# Motherboard

Reverse Engineered schematic of a two-DIP-switch Excelerator Plus drive.

**Title: Excelerator Plus reverse-engineered by itsP!**

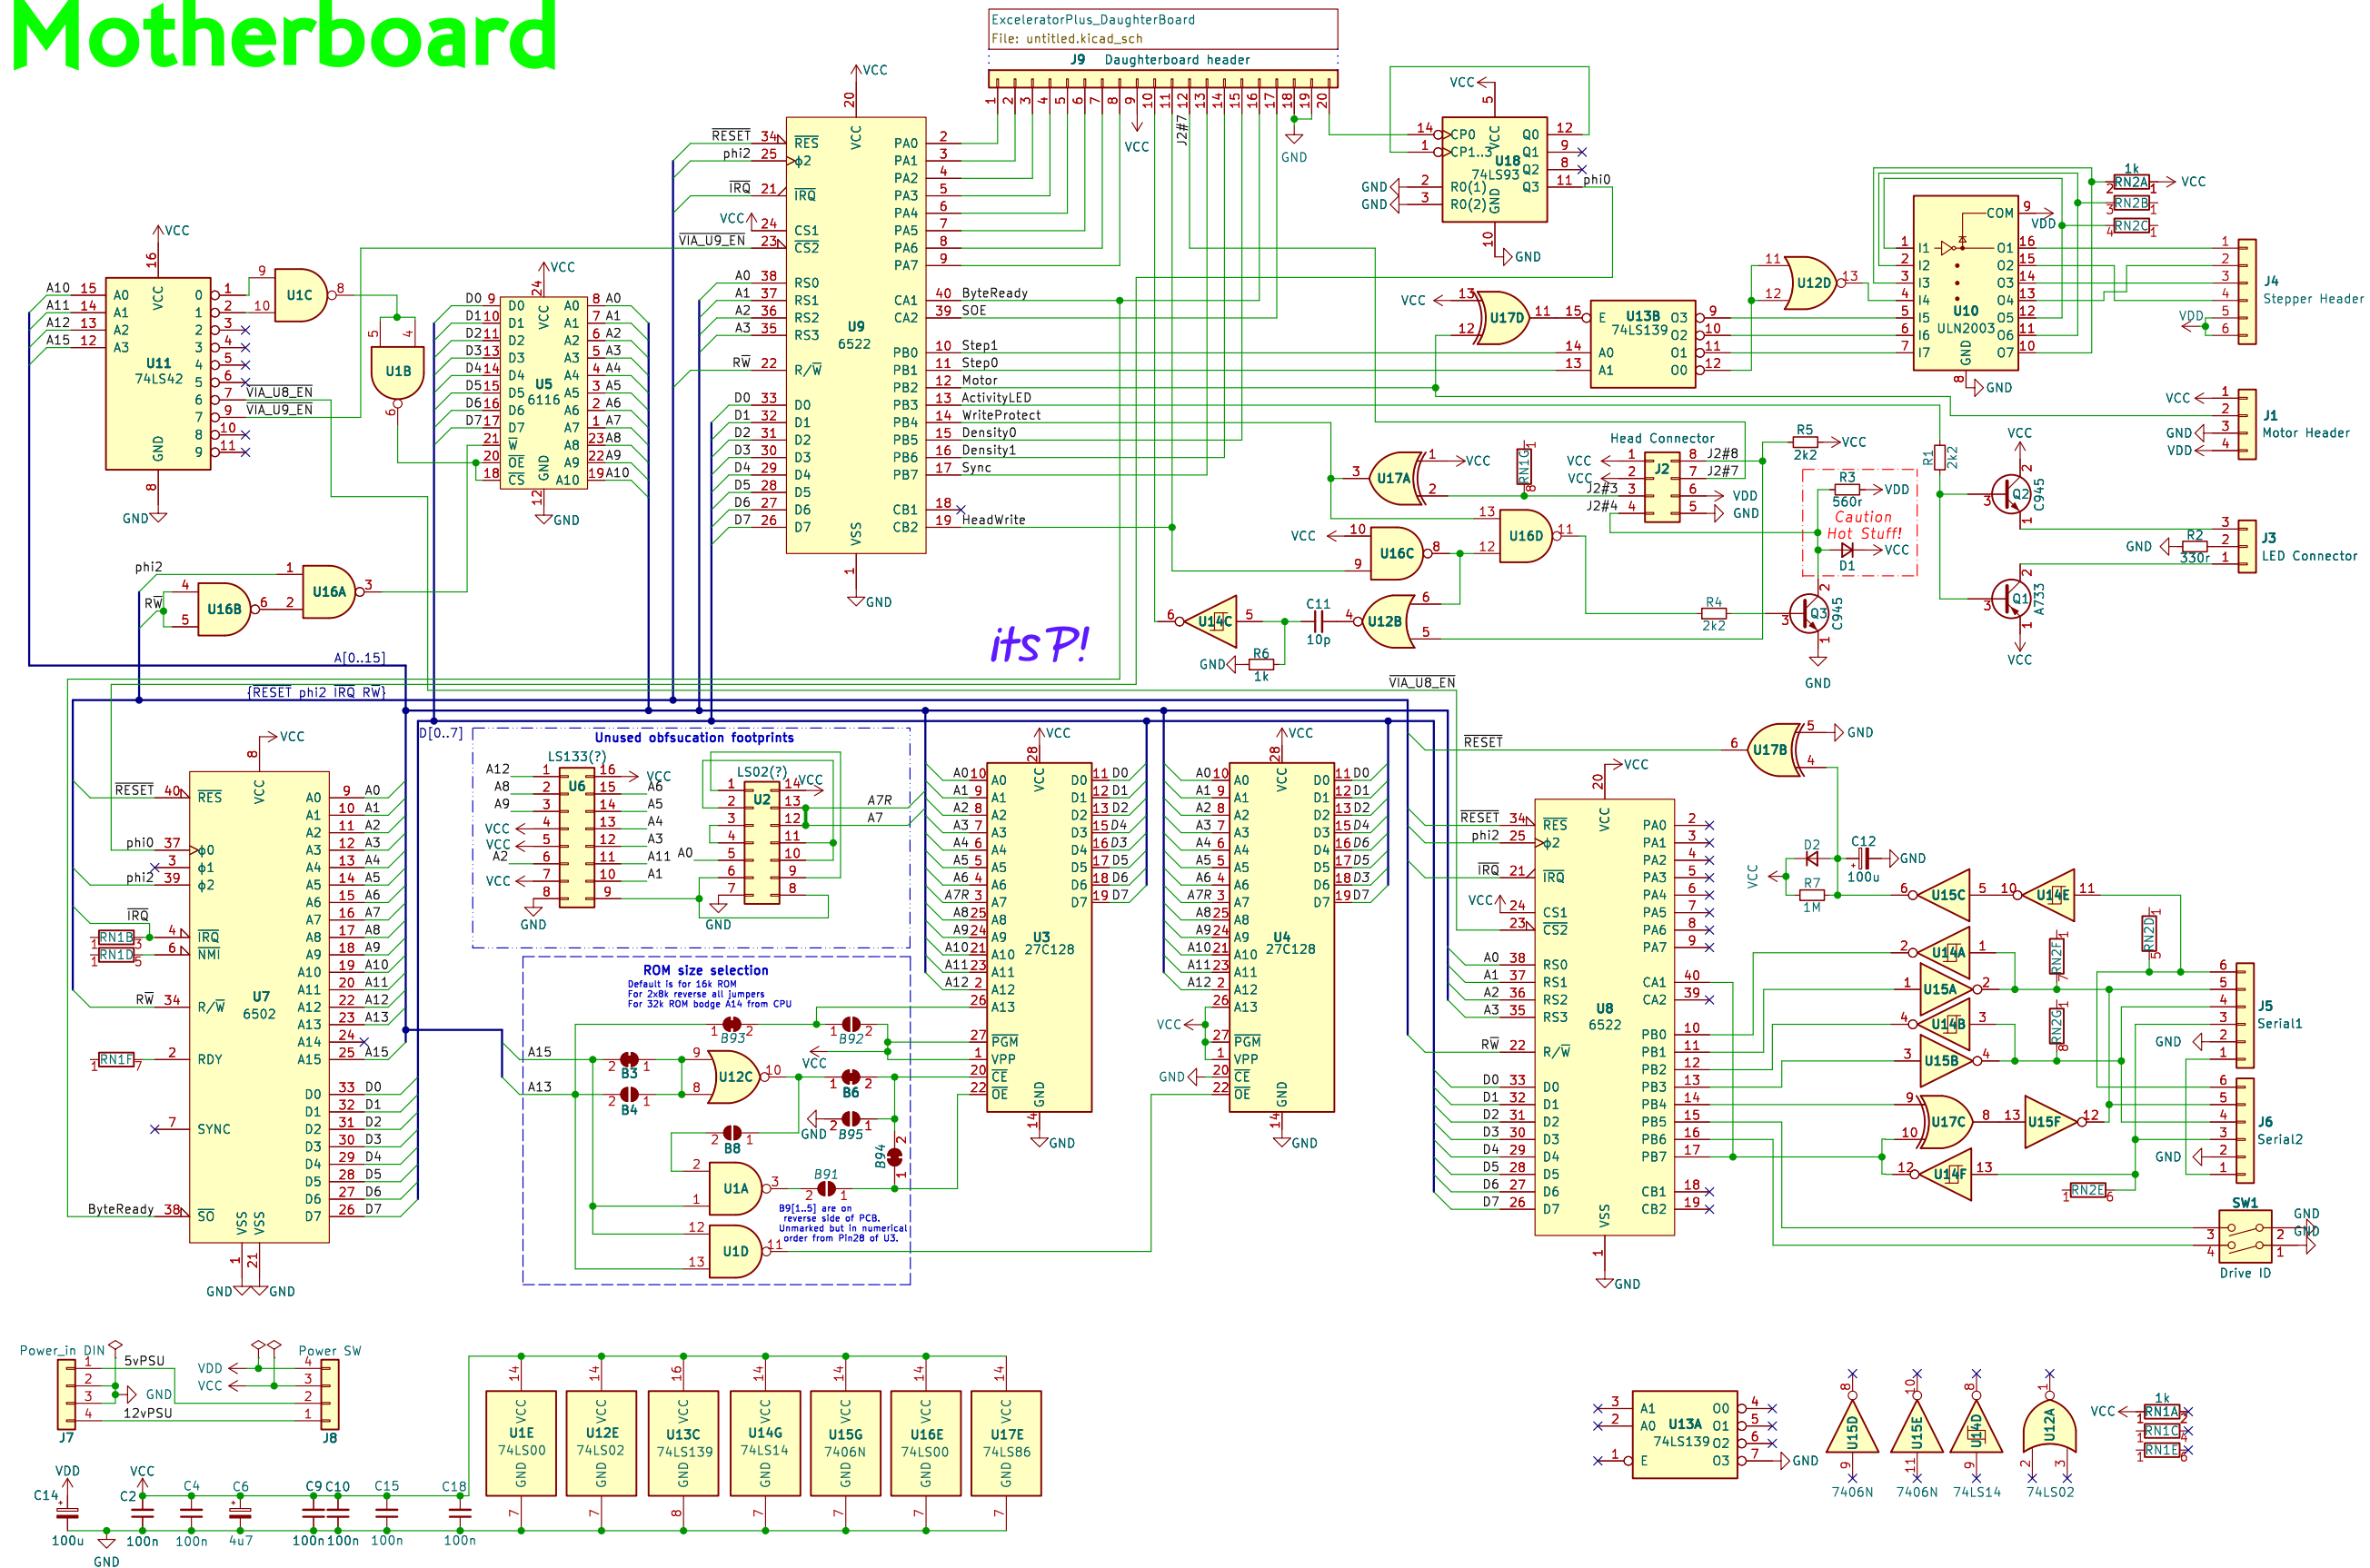
Suggested Improvements:

- Move Cathode of D1 to VDD
- Lift Pin 7 of U13 (erroneous GND connection)
- Tie all unused Inputs High
